CHANGE REQUEST

⌘ **04.08 CR** ⌘ rev **-** ⌘ Current version: **7.10.0** ⌘

Title:	⌘ Modification to MS's MM states to enable LCS signalling on RR layer		
Source:	⌘ Nokia		
Work item code:	⌘ LCS	Date:	⌘ 07.03.2001
Category:	⌘ F	Release:	⌘ R98
	Use <u>one</u> of the following categories: F (essential correction) A (corresponds to a correction in an earlier release) B (Addition of feature), C (Functional modification of feature) D (Editorial modification)		Use <u>one</u> of the following releases: 2 (GSM Phase 2) R96 (Release 1996) R97 (Release 1997) R98 (Release 1998) R99 (Release 1999) REL-4 (Release 4) REL-5 (Release 5)
	Detailed explanations of the above categories can be found in 3GPP TR 21.900.

Additions to Figure 4.1.a/GSM 04.08

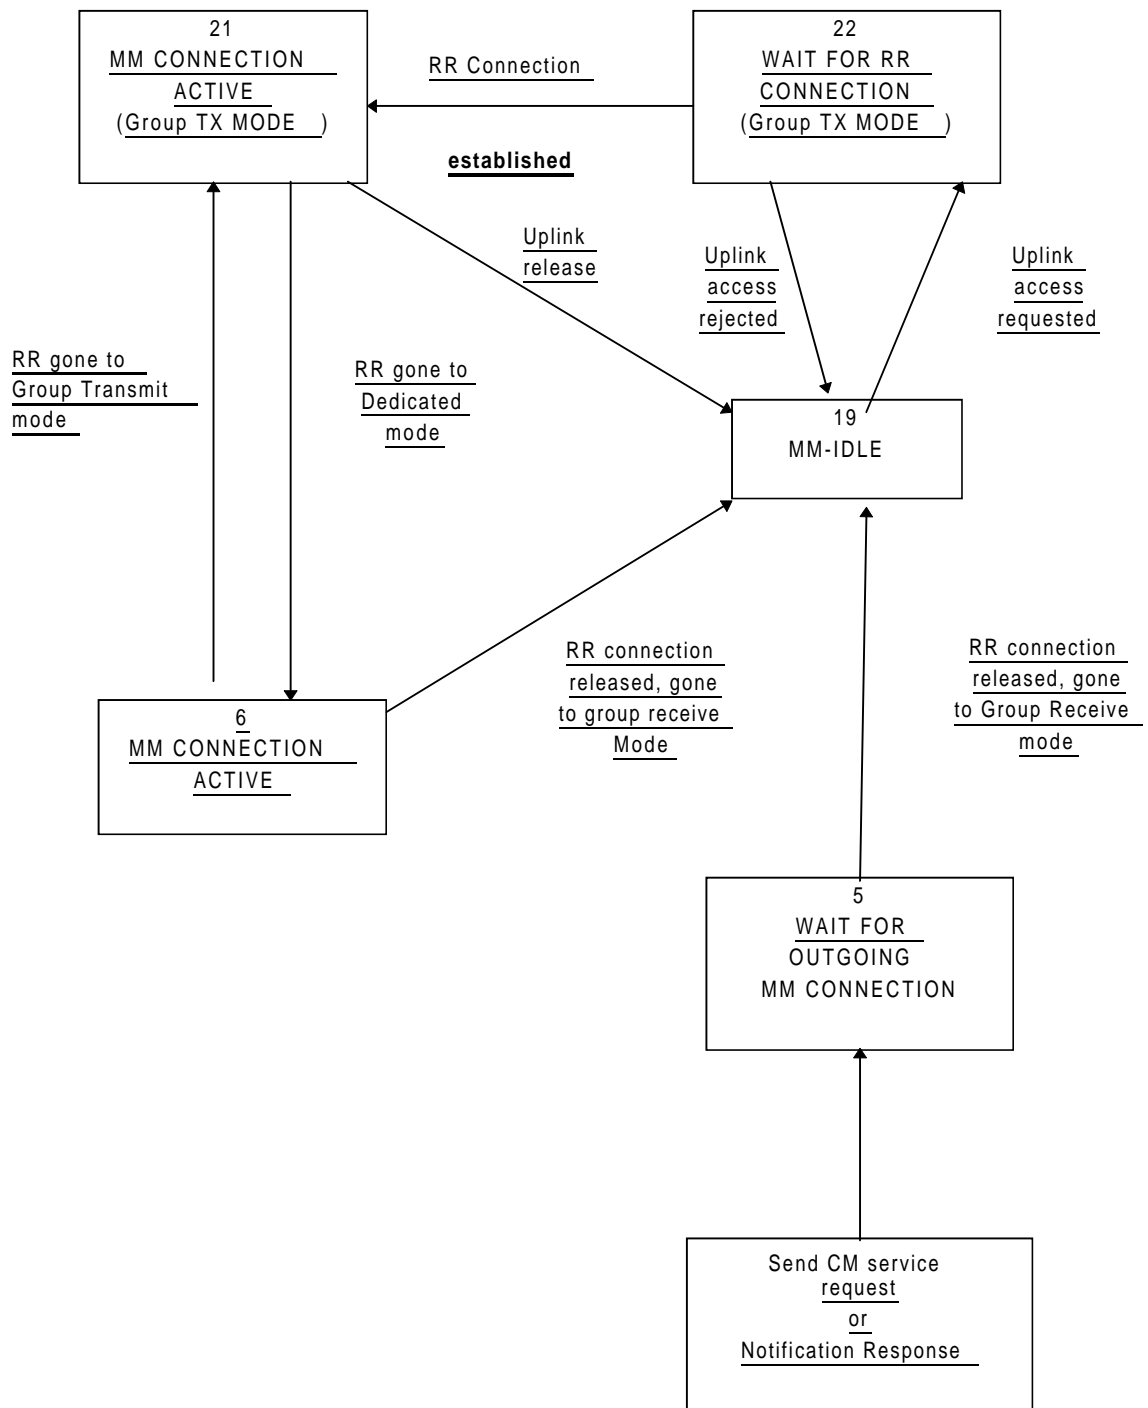
Reason for change:	⌘ LCS communication occurs in RR layer. For MT-LR/NI-LR case the MM layer is not active (from MS point of view) after authentication which causes that RR connection will be closed even if RR is needed for LCS signalling. The connection is closed by MS via T3240 timer within 10 seconds after last MM interaction. The LCS signalling may take longer than 10 seconds. This correction enables to stop T3240 timer and transit to a new MM state when RR layer sends indication to MM layer using RR-No-Abort-Ind (no abort) RR-SAP service primitive. The return to the normal MM operation occurs when RR-No-Abort-Ind (abort allowed) RR-SAP service primitive is received from RR layer. A new timer T32xx is added to guard the new MM state. This change together with CR to 04.07 (addition of RR-No-Abort-Ind primitive at RR-SAP in MS side) will correct the problem.
Summary of change:	⌘ The definition of a new MM state RR CONNECTION RELEASE NOT ALLOWED is added and the state transitions to/from the new state are defined. A new timer T32xx is defined.

25. RR CONNECTION RELEASE NOT ALLOWED

(Only applicable for MSs supporting LCS) There is no MM procedure running but RR connection exists. The timer T32xx is running.

When in state WAIT FOR NETWORK COMMAND, RR CONNECTION RELEASE NOT ALLOWED state is entered, if RR-No-Abort-Ind (no abort) has been received (in this or any of the other MM states).

In above state transition, timer T3240 is stopped and reset but not restarted. Timer T32xx shall be started.
